Product Change Notification / JAON-28QFPB827

CCB 5014 Initial Notice: Qualification of a new die size (1.932x1.860mm) for Die #1 of selected Microsemi LE9641PQC, LE9651PQC, LE9641PQCT, and LE9651PQCT catalog part numbers (CPN) available in 48L VQFN (7x7x1.0mm) package assembled at ASEM assembly site.

PCN #: JAON-28QFPB827

CCB 5014
Pre and Post Change Summary
PCN#: JAON-28QFPB827

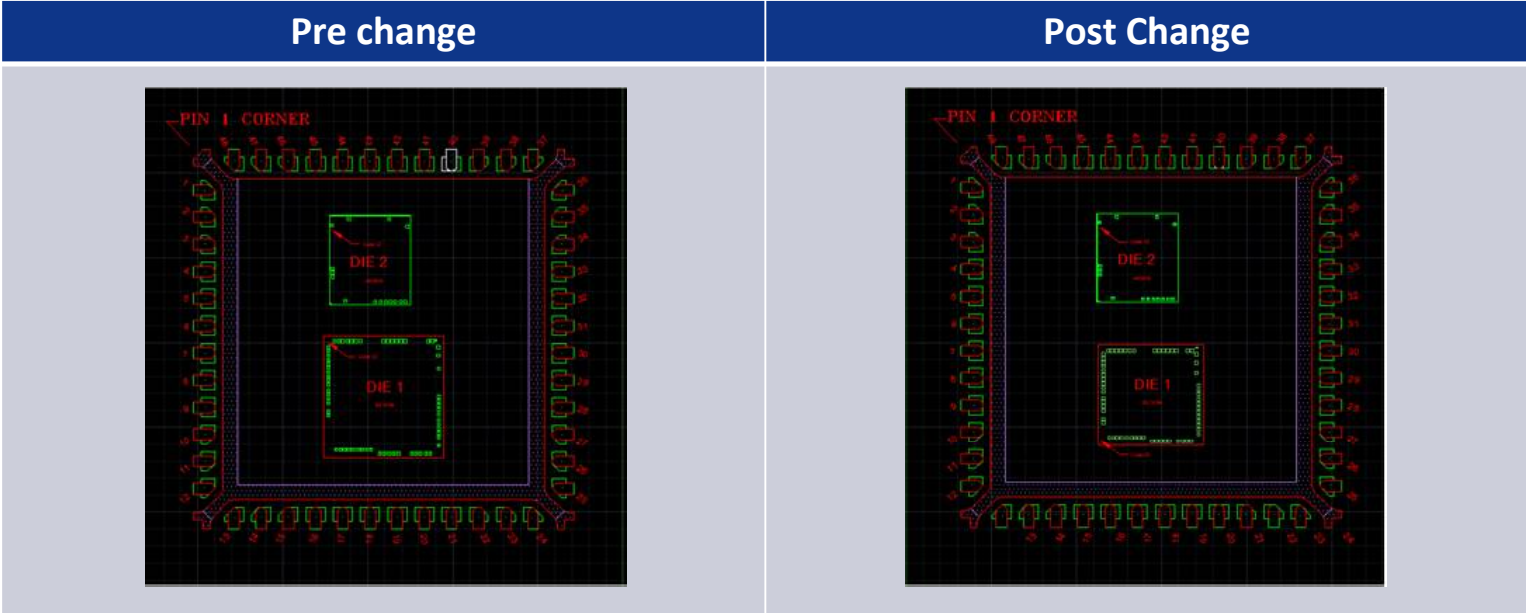
Description of Change:Qualification of a new die size (1.932x1.860mm) for Die #1 of selected Microsemi LE9641PQC, LE9651PQC, LE9641PQCT, and LE9651PQCT catalog part numbers (CPN) available in 48L VQFN (7x7x1.0mm) package assembled at ASEM assembly site.
